**DeKalb County Department of Planning & Sustainability**

**STAFF ANALYSIS**

**Case No.:** SLUP-21-1244886 **Agenda #:** D7

**Request:** Special Land Use Permit (SLUP) request to allow for a drive-through restaurant.

PRELIMINARY SITE PLAN

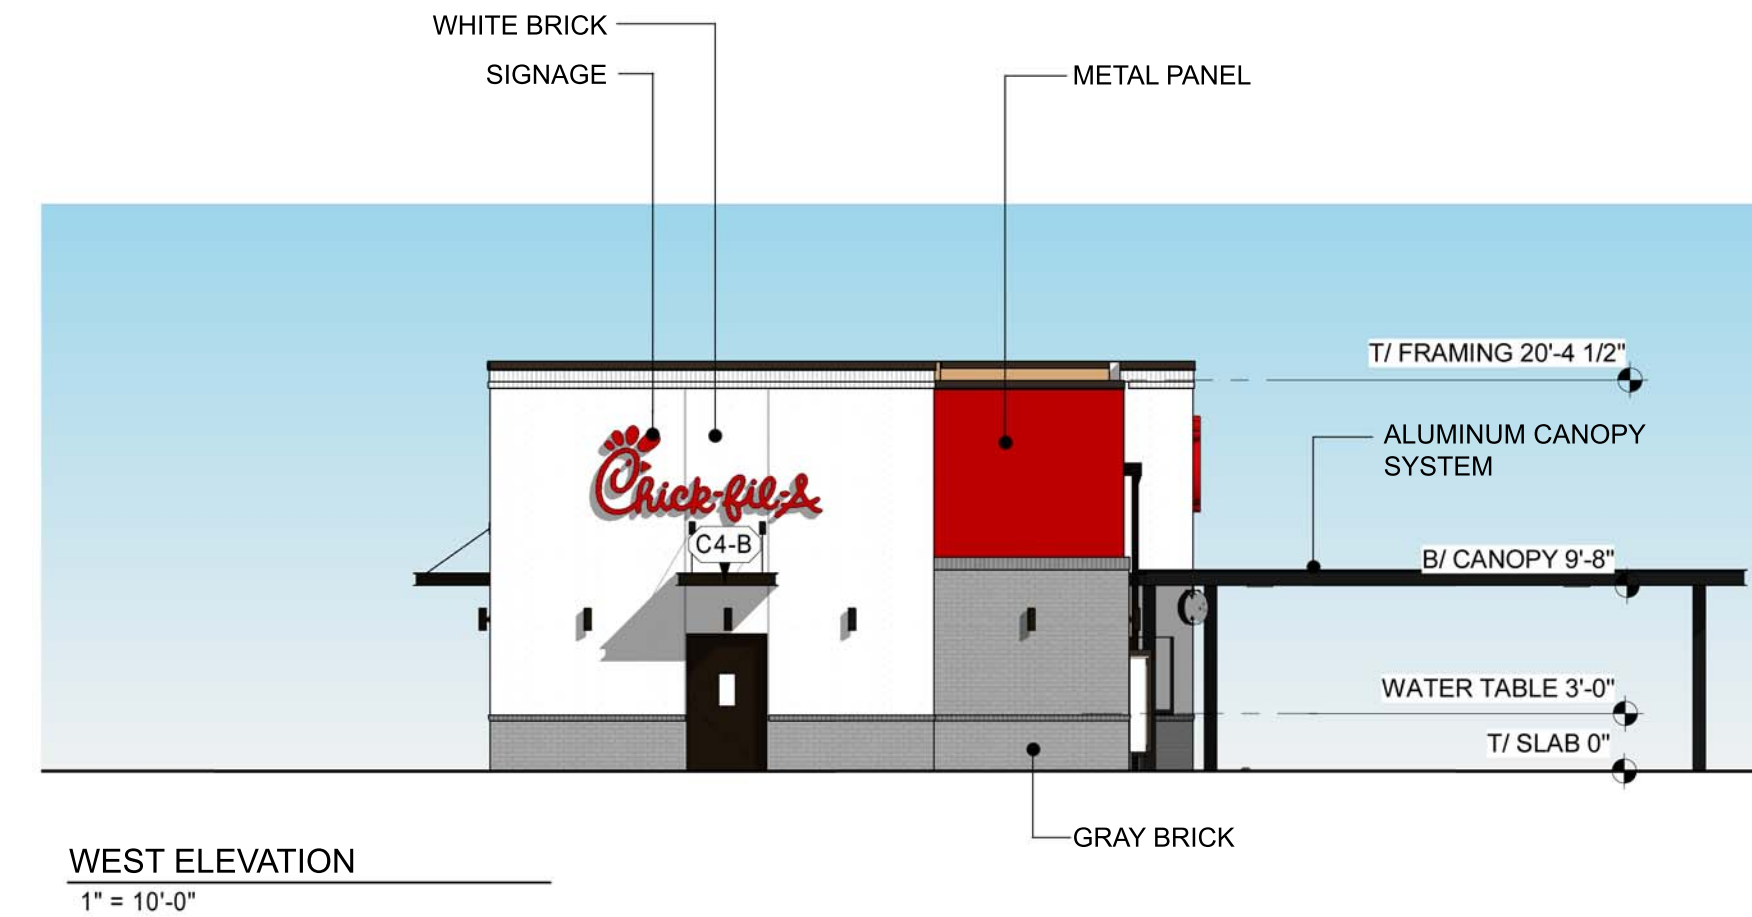
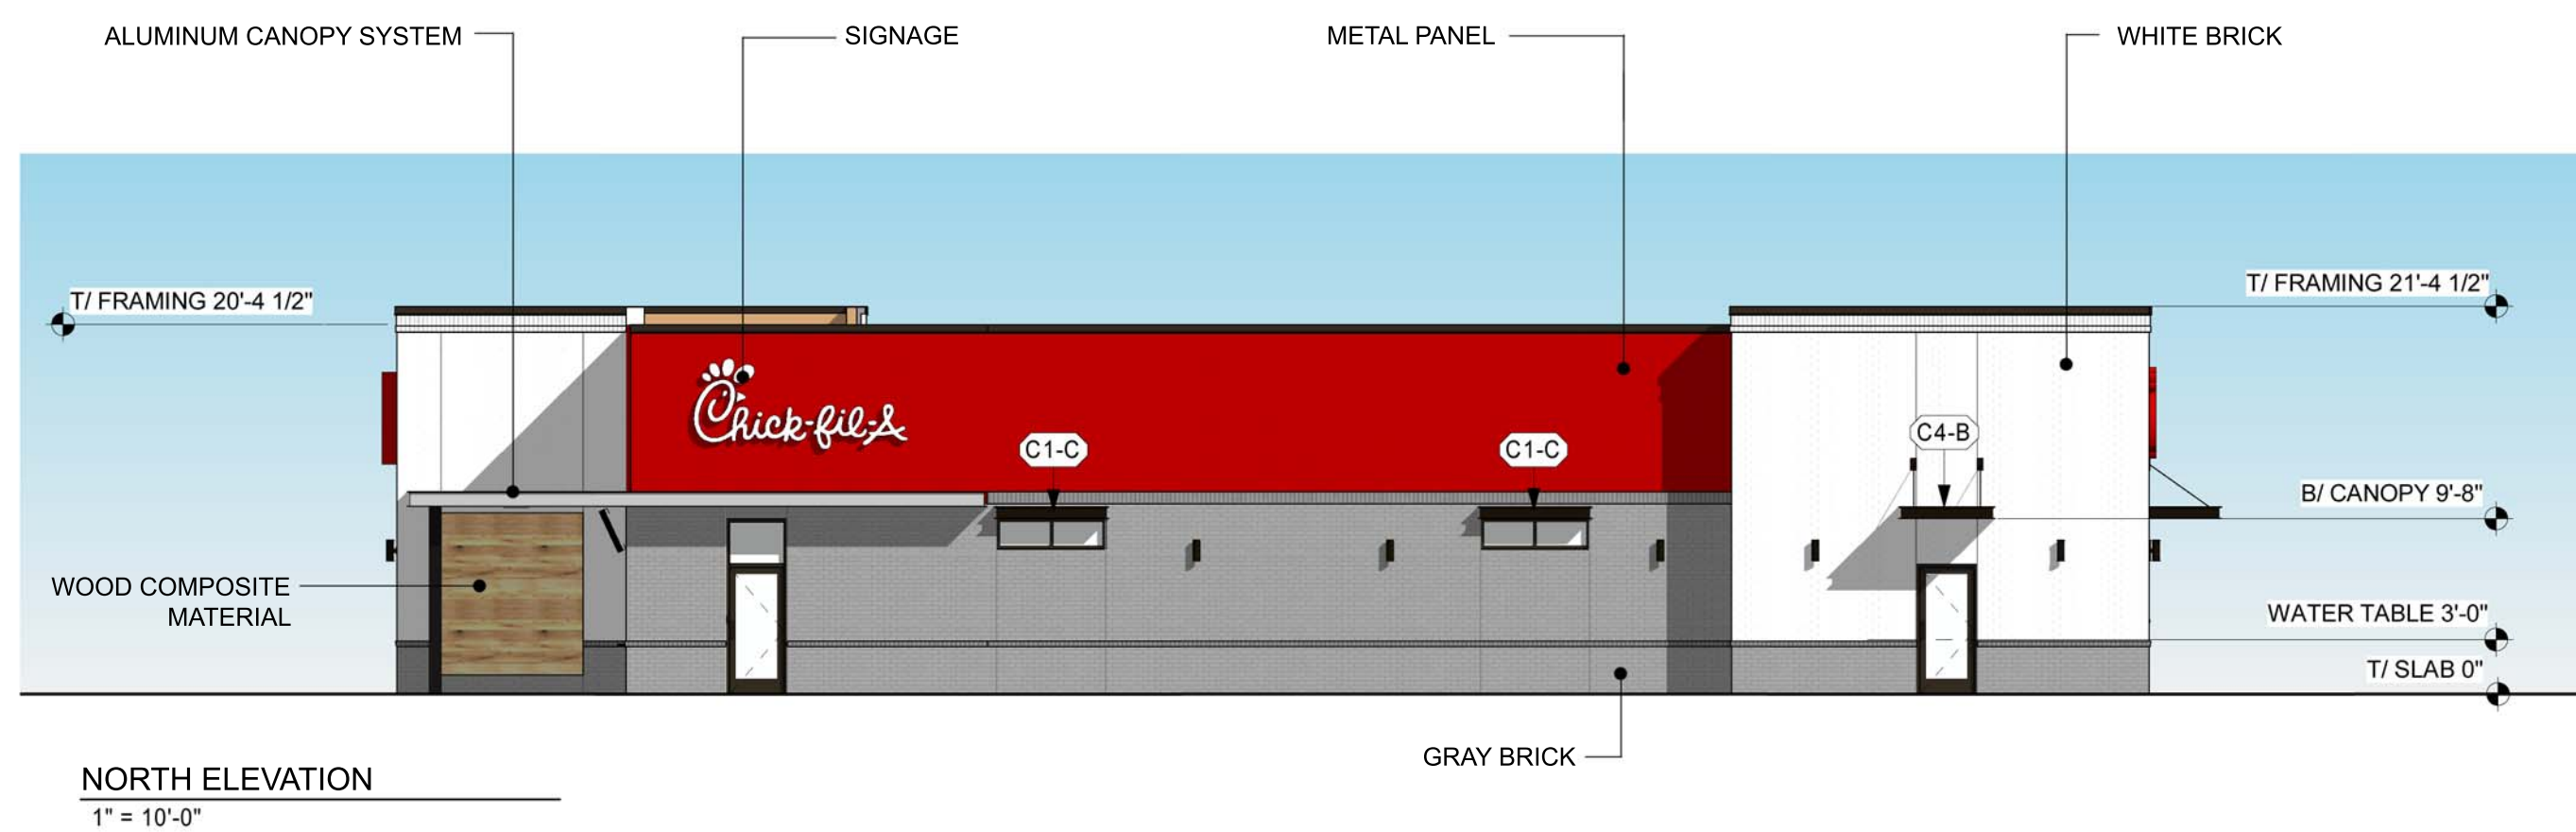
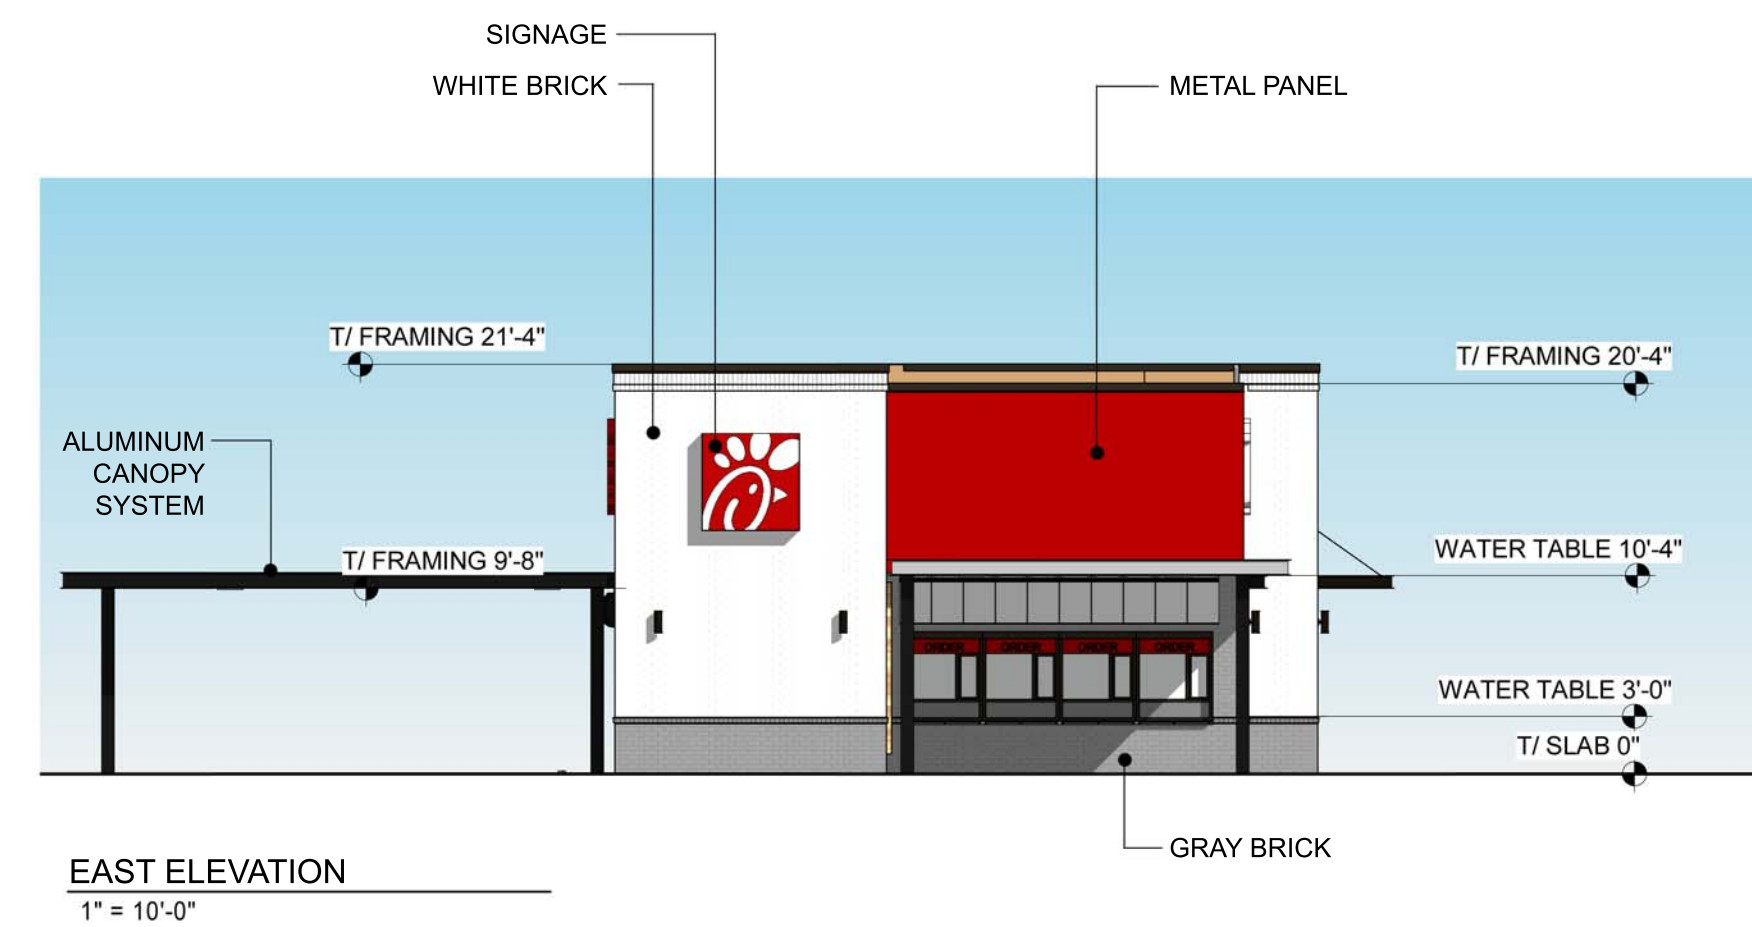
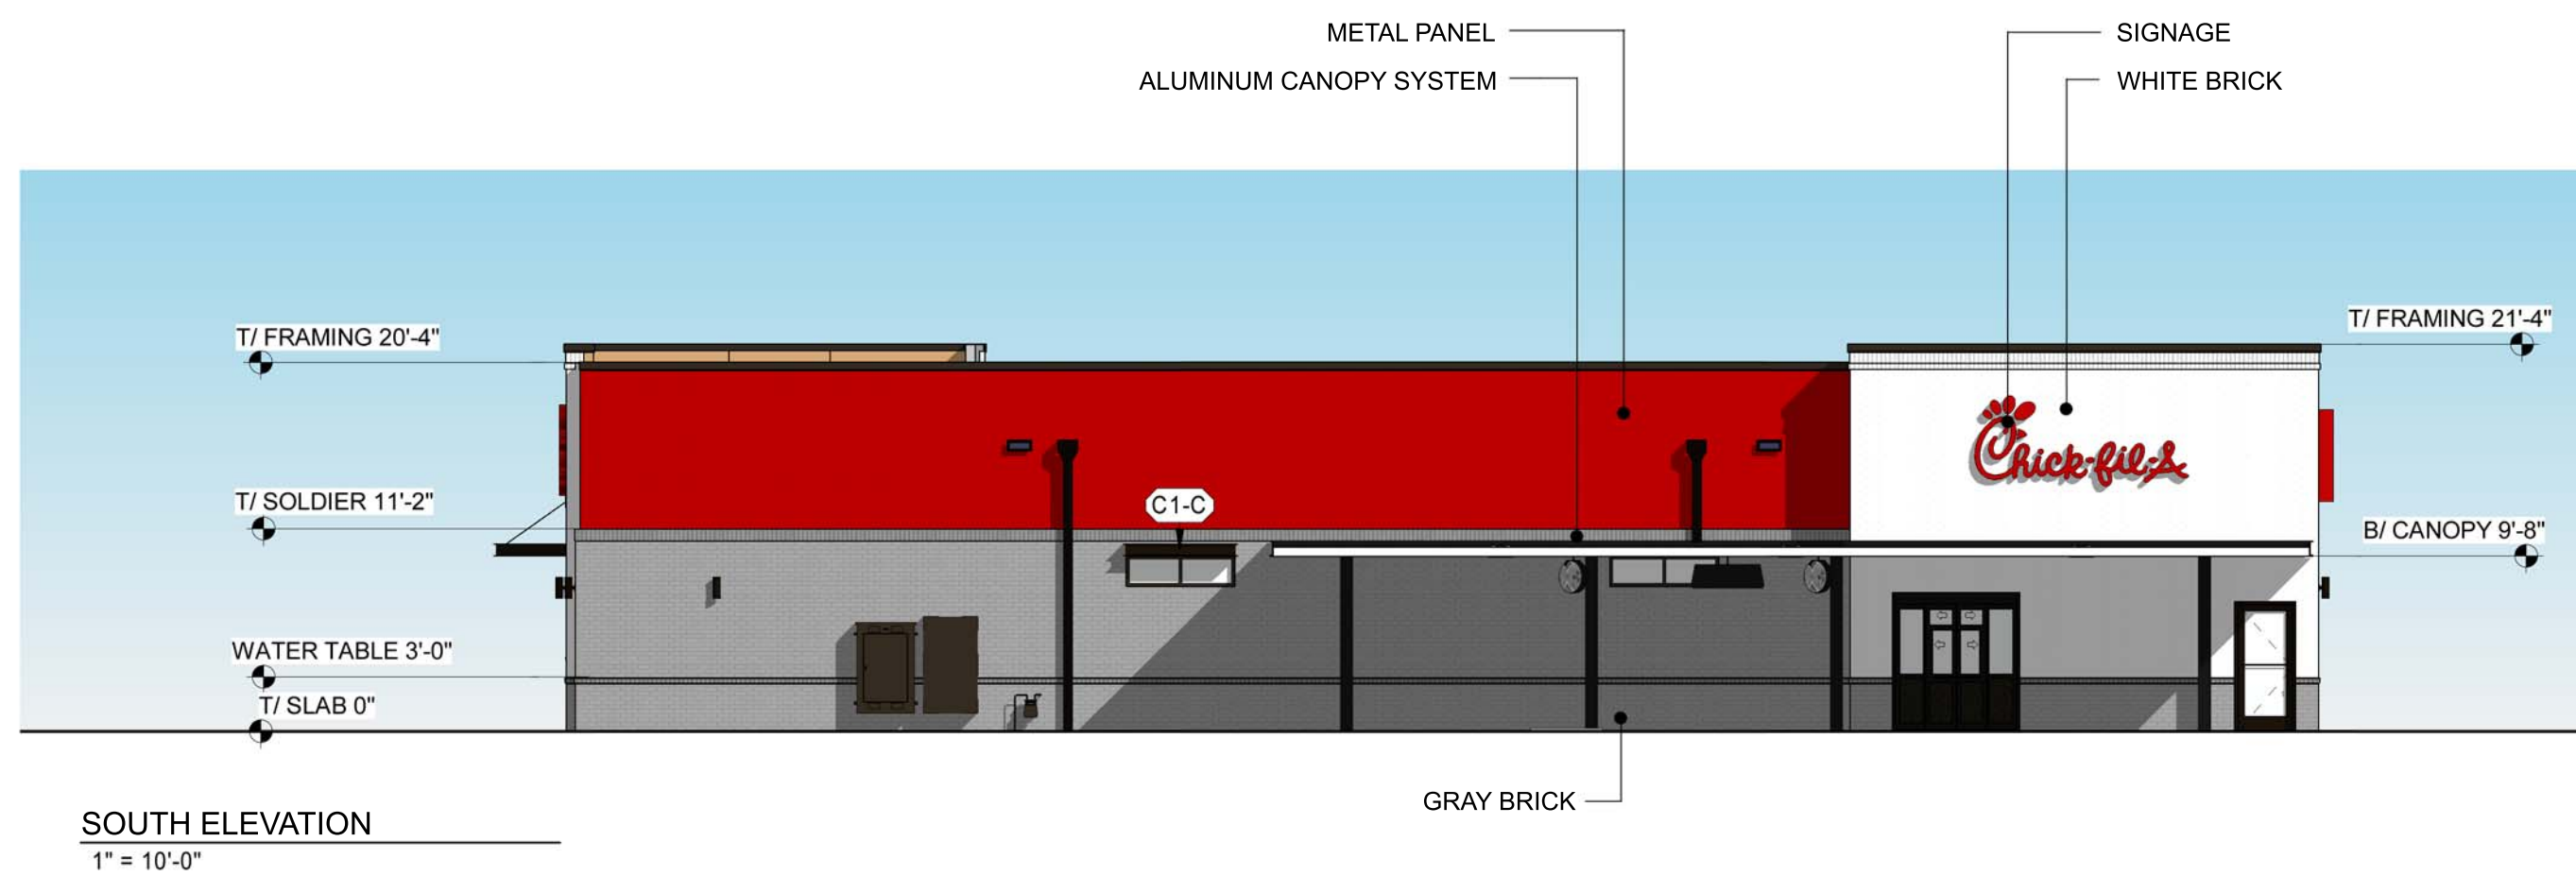
According to the site plan, internal circulation is centered on a "horseshoe" pattern to access three canopied drive-through lanes that narrow to two lanes for food delivery and parking around the perimeter of the site. Assuming the bulk of sales are via drive-through service, the proposed circulation plan may create a few issues: 1. the two parking spaces for disabled patrons are away from the building and close to the right in/right out access point at North Druid Hills Road; 2. drive-thru patrons who have received their food will also depart near the handicapped spaces and as patrons enter from North Druid Hills; and 3. given the proposed layout, reasonable signage may be necessary to ensure internal circulation flows as intended.

- d. **Drive-through canopies and other structures, where present, shall be constructed from the same materials as the primary building and with a similar level of architectural quality and detailing.** *Per submitted plans, it appears that the canopies will be constructed with the same materials as the building.*

- g. **Stacking spaces shall be provided for any use having a drive-through facility or areas having drop-off and pick-up areas in accordance with the following requirements. Stacking spaces shall be a minimum of ten (10) feet wide and twenty-five (25) feet long. Stacking spaces shall begin at the last service window for the drive-through lane (typically the "pick-up" window).** *Per the submitted preliminary site plan the stacking spaces are 11.5' wide and meet the 25' minimum in length.*

- h. **All drive-through facilities with the exception of drive-through restaurants shall provide at least three stacking spaces for each window or drive-through service facility.** *Per the submitted preliminary site plan there are 41 car stacking spaces are provided.*

- ii. **Drive-through lanes shall be separated by striping or curbing from off-street parking areas.** *Individual lanes shall be striped, marked, or otherwise distinctly delineated. Based on the submitted preliminary site plan there appears to be striping and material delineation shown to separate lanes.*
